SOUTH WAMBO
UNDERGROUND MINE MODIFICATION
RESPONSE TO SUBMISSIONS

For the Modification of DA 305-7-2003 (MOD 12)
The Realignment and Extension/Relocation of the
Approved South Wambo Underground Mine

June 2016

SOUTH WAMBO UNDERGROUND MINE MODIFICATION RESPONSE TO SUBMISSIONS

Figure 1a

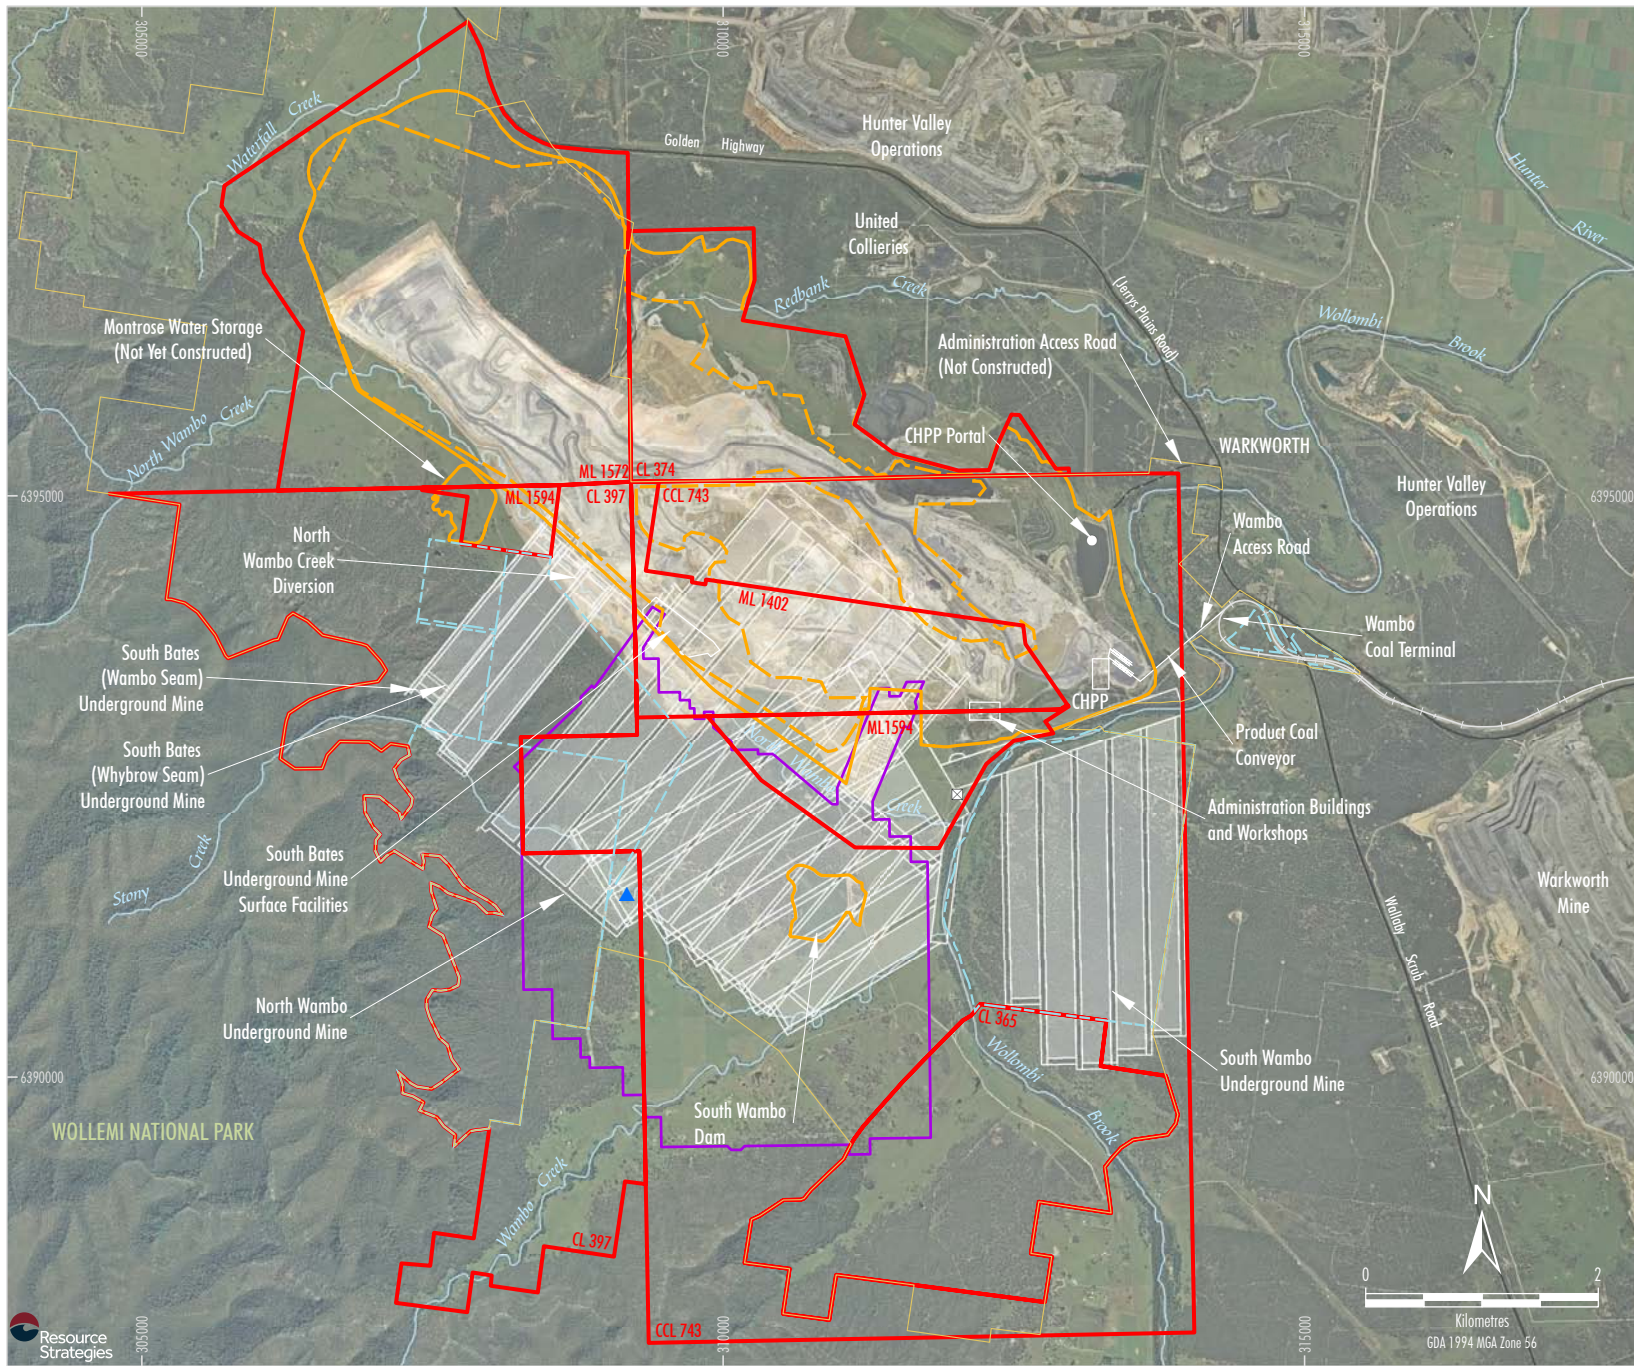
The location of the Abandoned Stony Creek Cottage Site is shown on Figures 1a and 1b.

As shown on Figure 1a, the Abandoned Stony Creek Cottage Site has been previously subject to subsidence effects from the North Wambo Underground Mine and previous mining in the Whybrow Seam. As shown on Figures 1a and 1b, the Abandoned Stony Creek Cottage Site would be subject to subsidence effects from the approved mine layout and modified mine layout of the South Wambo Underground Mine.

The Modification does not change the above conclusions as the predicted subsidence effects would be similar between the approved and modified mine layouts.

Figure 2

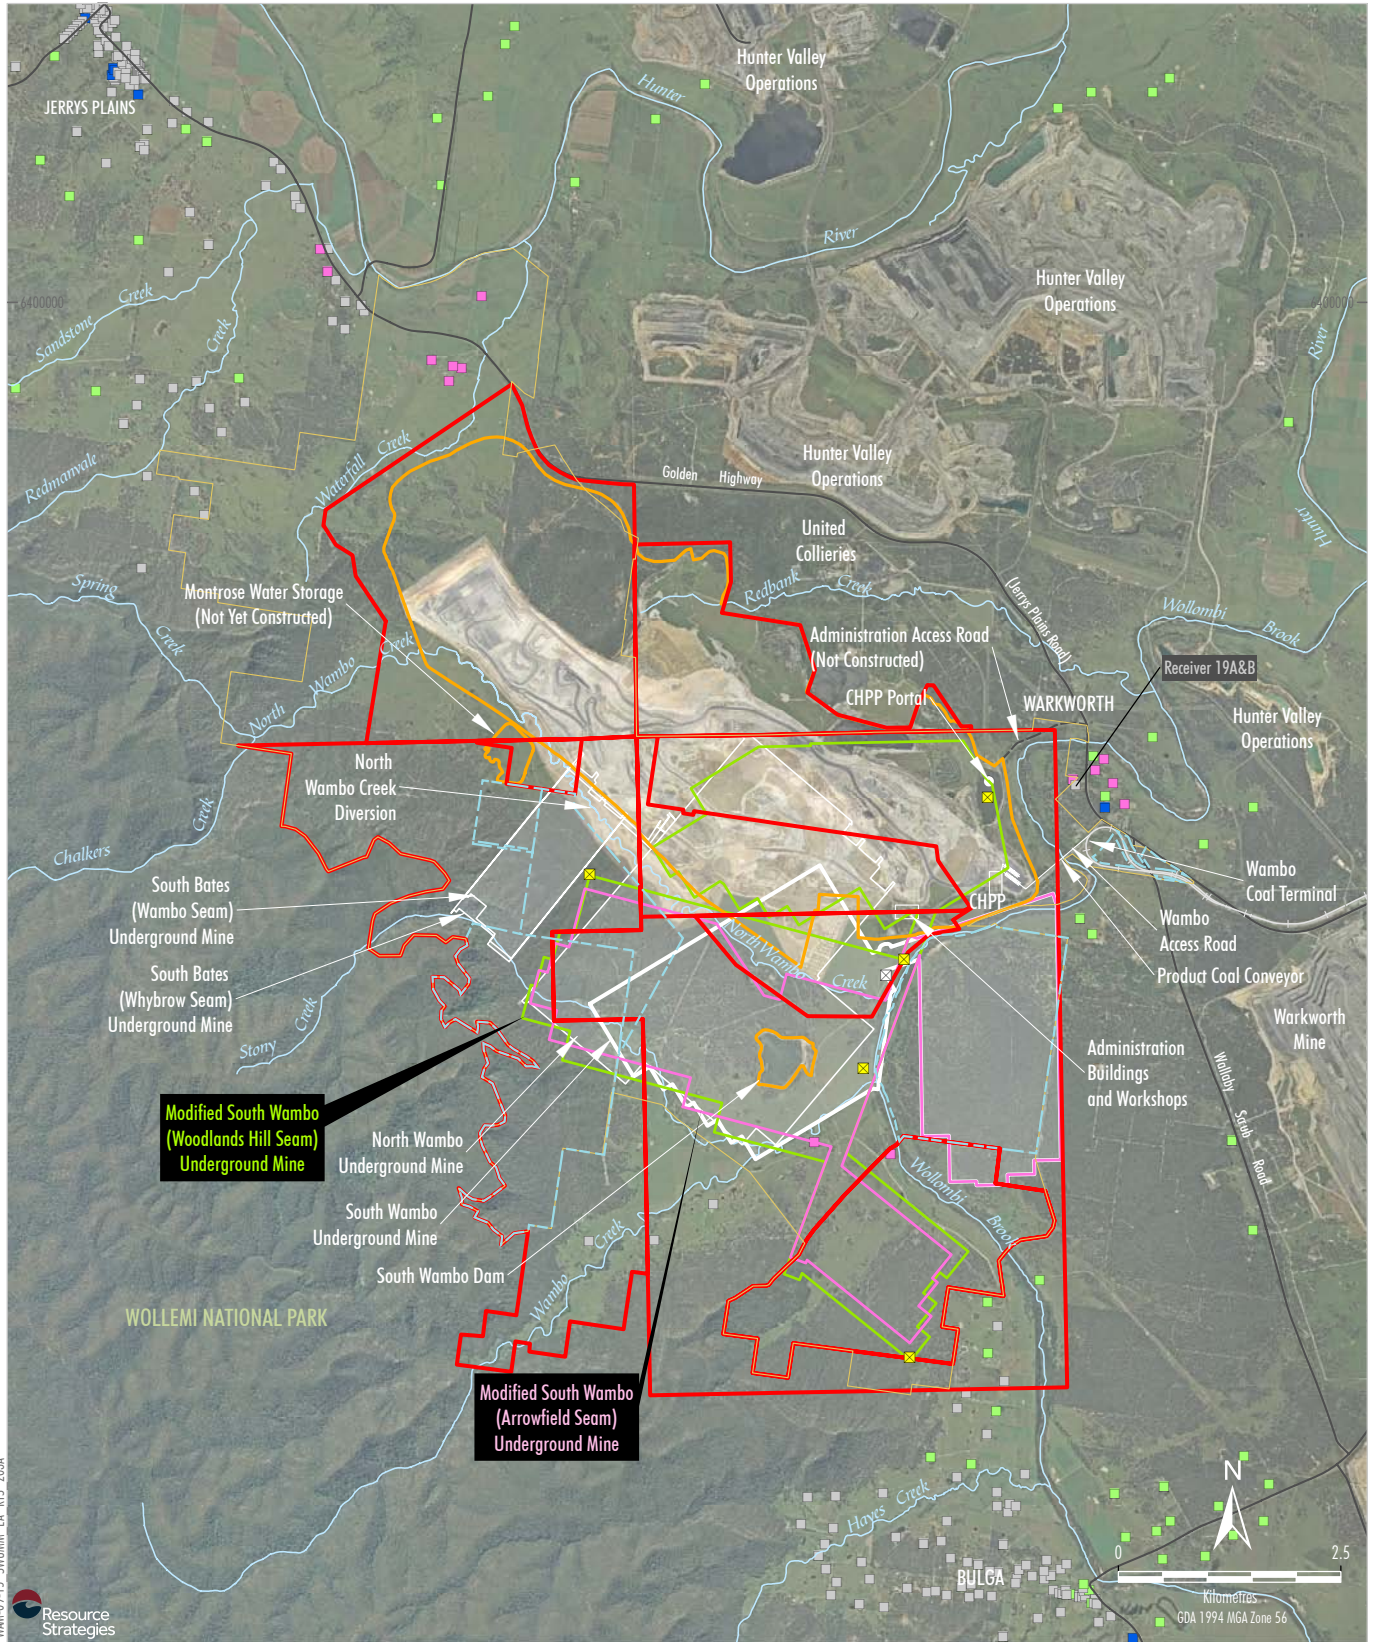
The DP&E requested further detail on the locations of gas management infrastructure, in particular a conceptual layout showing indicative locations.

Figure 2 provides conceptual locations of gas drainage boreholes. As described in Section 3 of the EA, there would also be general access tracks to facilitate maintenance and monitoring, water and gas pipelines, power infrastructure and up to two centralised gas plants. WCPL requests flexibility in the locations of gas management infrastructure, allowing for the final location of gas management infrastructure to be outlined in the relevant Extraction Plan and associated Mining Operations Plan (MOP).

Plate 1 – International Monetary Fund Energy Price Index and Trend Analysis

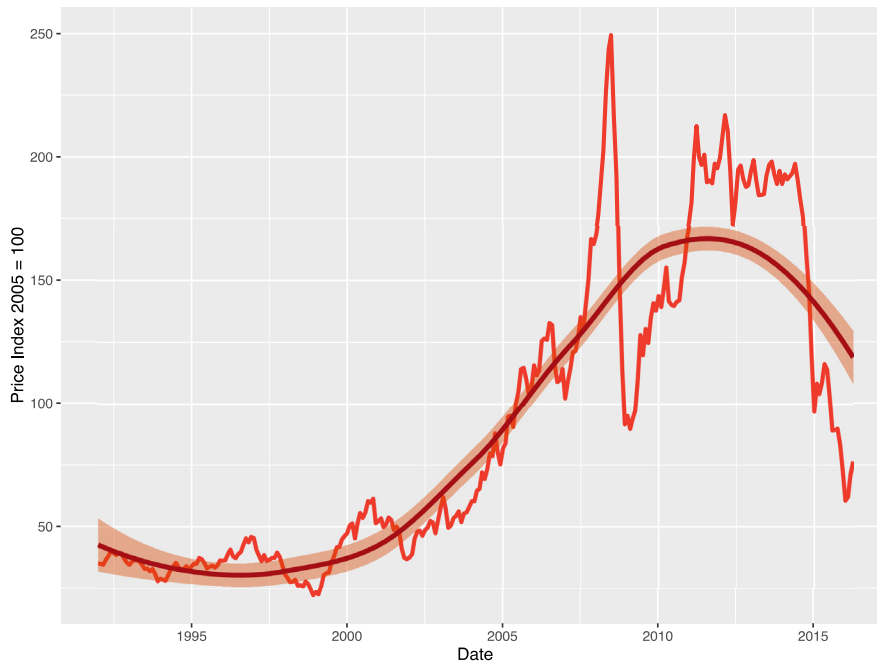
The Australia Institute raised concerns about the accuracy of the value of the Modification based on a comparison with Peabody Energy's market value.

Historically, Australian coal was predominantly sold under contract, and spot market trading remained thin until about the middle of the last decade. As a consequence, it is difficult to conduct a reliable long-term analysis of coal prices in order to ascertain the range of coal price outcomes. In the absence of a reliable long-term coal price series, AnalytEcon focused its analysis on a monthly energy price index published by the International Monetary Fund (IMF) that is made up of oil, natural gas and coal prices (which tend to move together) and that is available from 1996. The index is shown along with long term trend prices in Plate 1.

The trend underlying the index was computed by AnalytEcon using an optimal Loess smooth, a piecewise polynomial regression technique. It is clear that the index itself cycles around the trend, with periods where the index is either above or below the trend, and that current coal prices are well below trend. While the index is trending downwards, nothing can reliably be inferred by extrapolating the trend in the medium to longer term.

Given the above, WCPL considers that the export coal prices adopted in the Socio-Economic Assessment are realistic and the value of the Modification is not overstated.
